**Wollongong Coal Limited**  
**Russell Vale Colliery**  
**Underground Expansion Project**  
**Response to the**  
**Independent Expert Scientific Committee Advice**  
**June 2020**

<b>Document Control</b>	
<b>Site:</b>	Russell Vale Colliery
<b>Document ID:</b>	WCL_RV_EC_RPT_013
<b>Document Type:</b>	Report
<b>Date Published:</b>	15 June 2020
<b>Document Title:</b>	Russell Vale Colliery Underground Expansion Project Response to the Independent Expert Scientific Committee Advice
<b>Version Number:</b>	1
<b>Document Author:</b>	Ron Bush Group Environment and Approvals Manager Wollongong Coal Limited

**Figure 2: Pillar load/deformation characteristics for varying width/height ratios.**

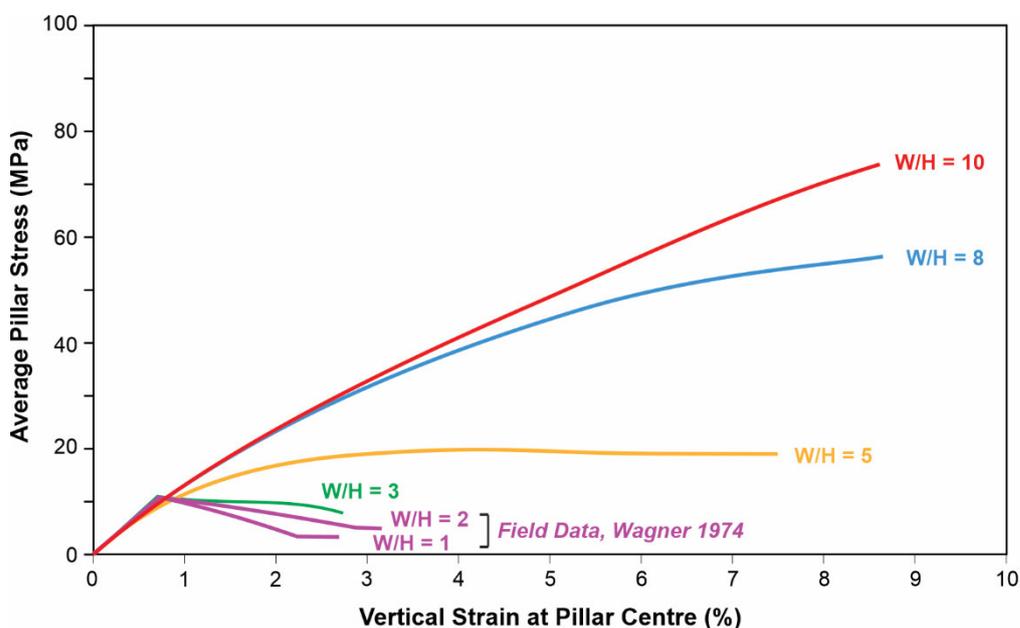
SCT makes reference to 1994 work in support of the data presented in Figure 2, showing w/h ratio pillars of 8 and 10 continuing to increase in their load-carrying capacity. Further in support of this position, the statement is made that “*pillar behaviour in the Wongawilli Seam is observed to be more consistent with strong roof and floor conditions allowing frictional strength to develop*”. This may well be the case based on the evidentiary data from 1994, but a further explanation of this claim should be provided here, given that in the 2019 Subsidence Assessment Report, SCT referenced the fact that the Wongawilli Seam roof was not strong. SCT stated in that report: “*despite Wongawilli Seam workings being characterised as having a weak coal/shale roof in a thick seam environment ...*” (SCT 2019, page 22).

Figure 1: Plan showing location of swamps and proposed first workings in the Wongawilli Seam relative to previous secondary extraction in Bulli Seam (Grey), Balgownie Seam (Red) and Wongawilli Seam (Dark Green).

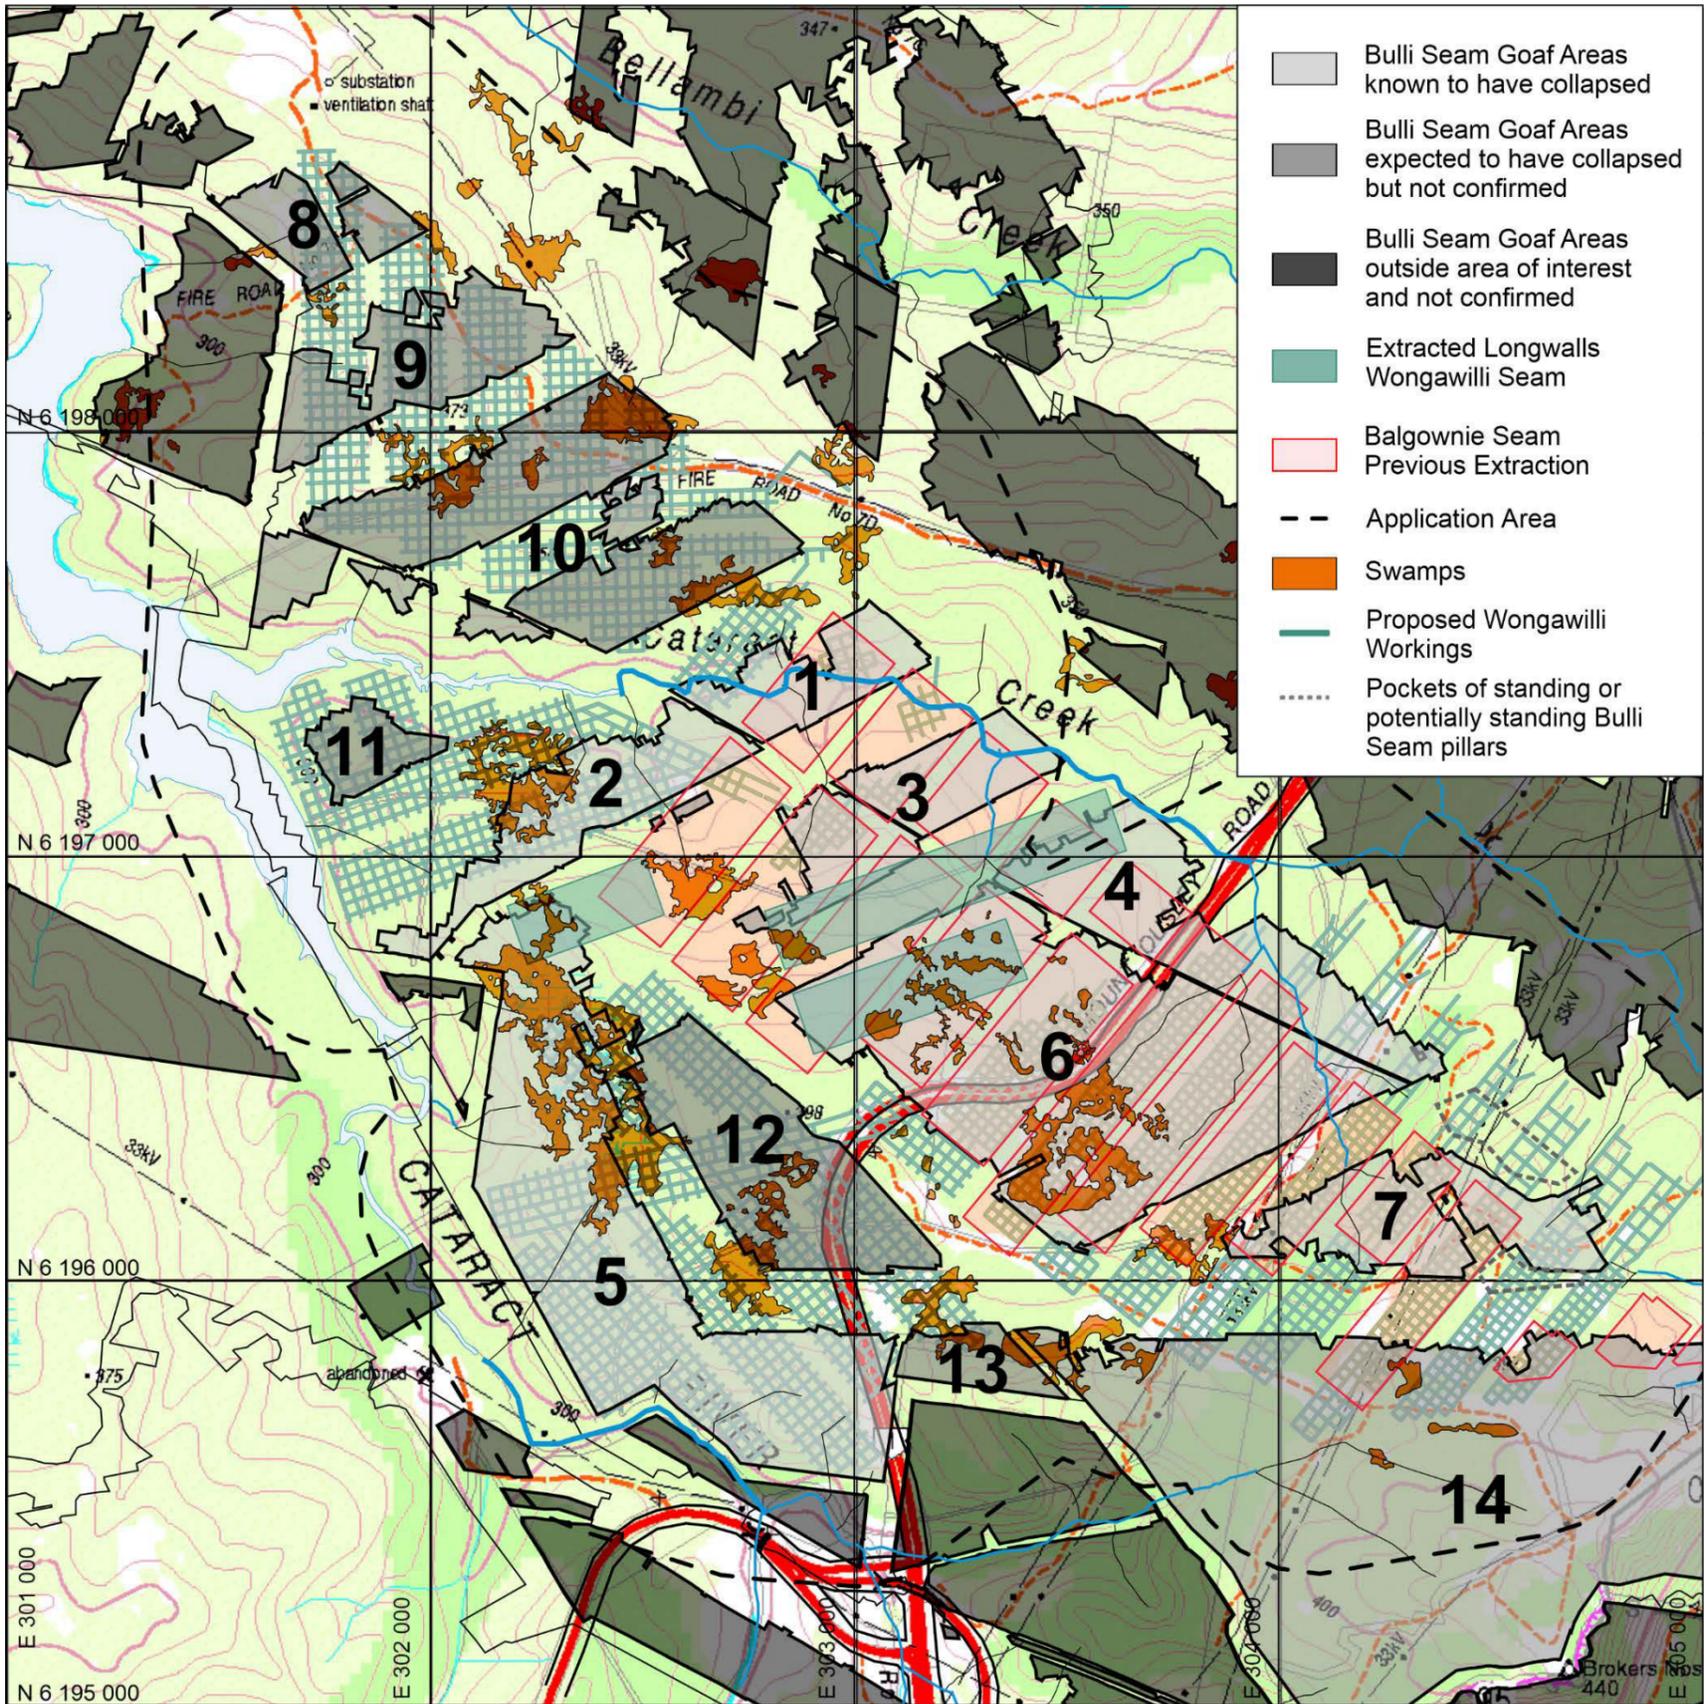
In particular, the discussion regarding Bulli Seam workings refers to seven goaf areas where the data confirms that full subsidence has already occurred. However, a further seven areas remain subject to question as to their status and should be further investigated. It would be helpful if SCT provided plans showing specific locations for each of these fourteen goaf areas, and the seven, in particular, that are under some doubt, including the location of any swamps overlying them.

Figure 1 shows fourteen large areas of Bulli Seam pillar extraction, referred to as Bulli Seam goaf areas. There is evidence available from subsidence monitoring and observation of roadway conditions in the Wongawilli Seam to confirm seven of these areas have fully collapsed with no potential for further subsidence. The seven collapsed goaf areas are numbered in Figure 1 as 1-7.

It is almost certain that the other seven goaf areas (8-14) have also fully collapsed because the mining systems used in each are similar and the areas extracted are of similar size. Confirmation of collapse in all these areas would be reassuring for the sake of completeness. Proposed mining in the Wongawilli Seam would not change the potential for further subsidence from the Bulli Seam. This potential would exist irrespective of proposed mining. The benefit of knowing that all the Bulli Seam goaf areas have collapsed and fully subsided is that this risk could then be eliminated.

15. to 19. These remaining comments addressed the issue of stability of pillars in the overlying seams, and the condition of 14 Bulli Seam goaf areas. SCT has now provided far greater clarity with regard to the goaf areas, providing a numbered plan (Figure 1) showing all of the goaf locations relative to both mining panels and surface swamps. The seven goaf areas where there remains some uncertainty about their condition are noted as goaf numbers 8 to 14. SCT asserts that it is likely that these goaf areas have also fully subsided, as have 1 to 7, but further confirmation of this status is needed – to be established by mining conditions whilst undermining.
